## PUBLIC WORKS DEPARTMENT

**To: La Center 2025 Guardrail Repair Project Bidders**

**Item: Addendum #1**

### **Guardrail note revisions:**

DESIGNED	ALC
DRAWN	ALC
CITY PROJECT #	001
HOR.	NONE
VERT.	NONE
DATE	January 2025
DWG.	2025 GUARDRAIL
SHEET	2 OF 4

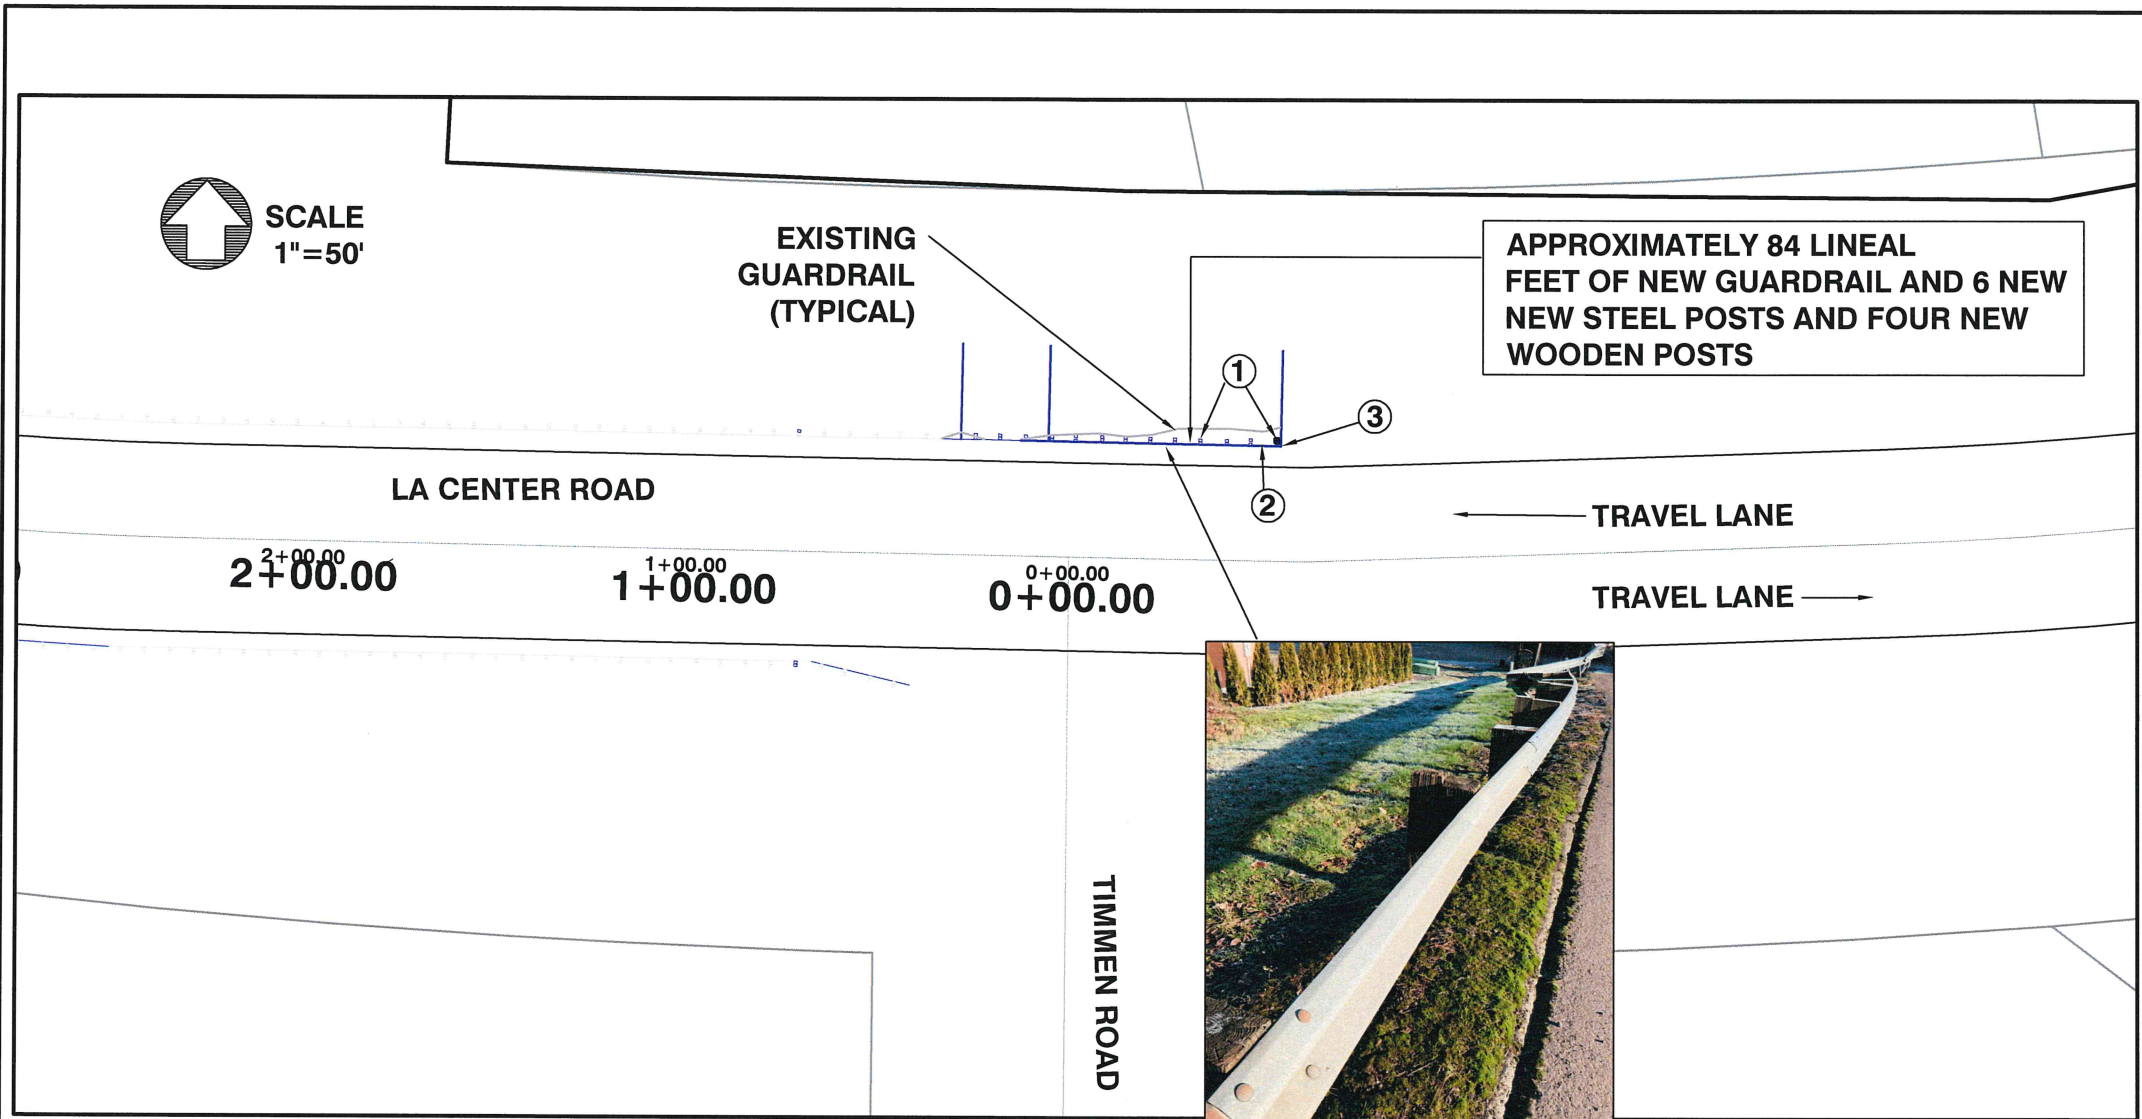
Plan sheets 2, 3 and 4 are being revised to show the length of the guardrail and the height above finished grade, per WSDOT details. The plans sheets are attached.

- ① WOODEN I-BEAM POST
- ② GUARDRAIL REPLACEMENT PER WSDOT  
STD PLANS ATTACHED
- ③ THE LENGTH OF THE WOODEN I-BEAM  
POSTS SHALL BE 11-FEET MINIMUM OR AS  
RECOMMENDED. HEIGHT OF GUARDRAIL PER  
WSDOT PLAN C-20.10-09 ATTACHED
- ④ SEE WSDOT SPECIFICATIONS FOR INSTALLATION

DESIGNED	ALC
	DRAWN	ALC
	CITY PROJECT #	
	HOR.	NONE
	VERT.	NONE
DATE	2-1-2025	
DWG.	GUARDRAIL	
SHEET	3	
OF	4

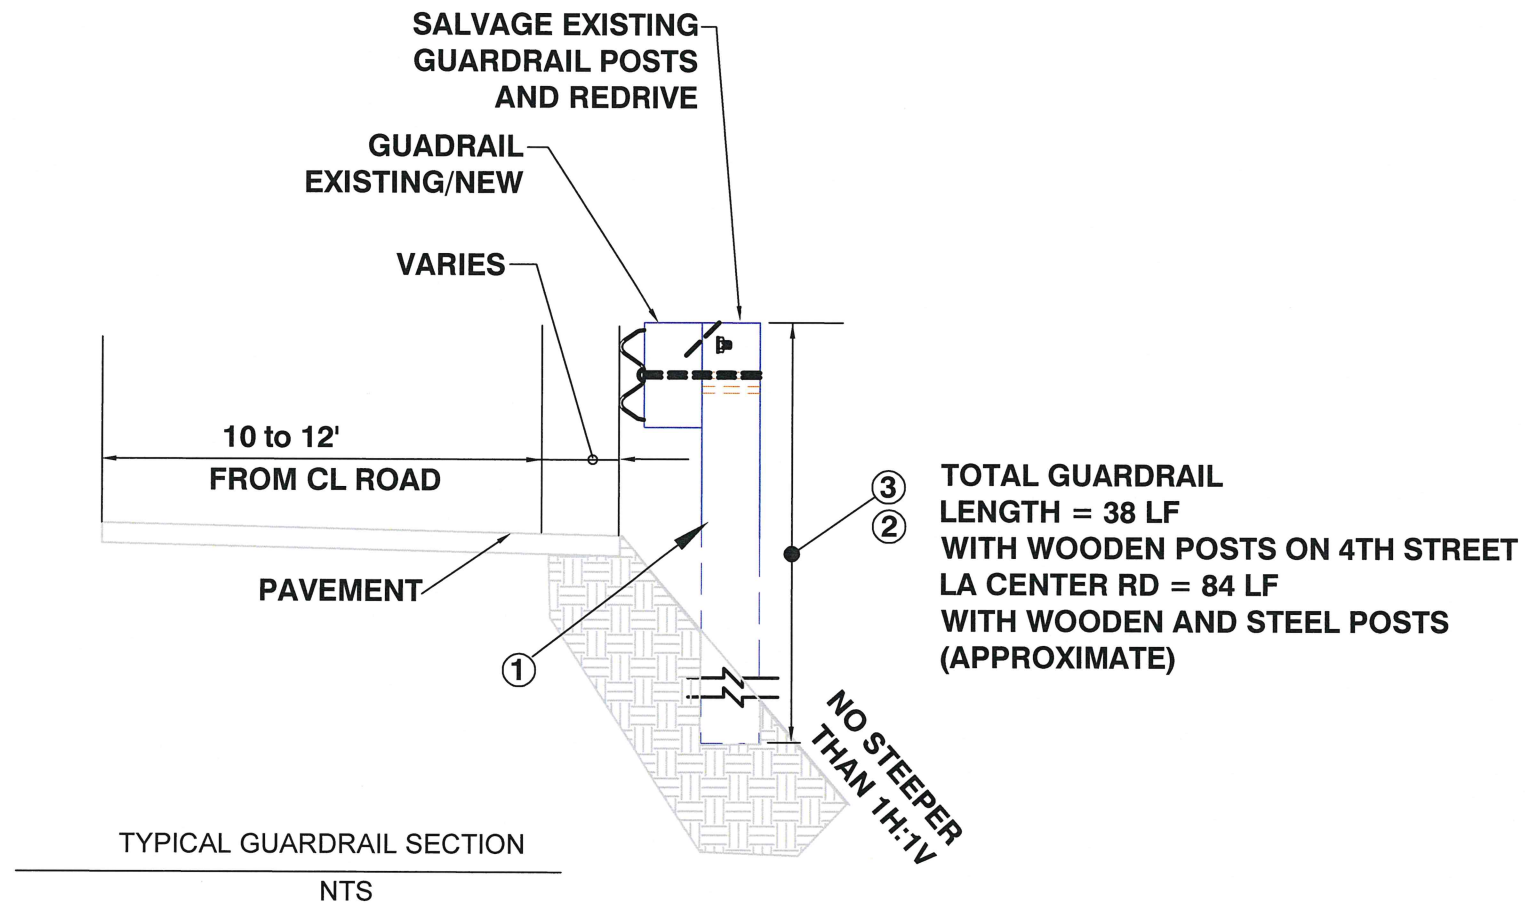
- ① STEEL I-BEAM POSTS
- ② BEGIN GUARDRAIL TYPE 31  
PER WSDOT STD PLAN C-20.10-09
- ③ BEGIN MSKT-SP-MGS TL-3 TERMINAL SECTION OR APPROVED WSDOT TERMINAL  
SECDTION PER WSDOT STANDARDS
- ④ THE LENGTH OF THE WOOD OR STEEL I-BEAM  
POSTS SHALL BE 11-FEET MINIMUM
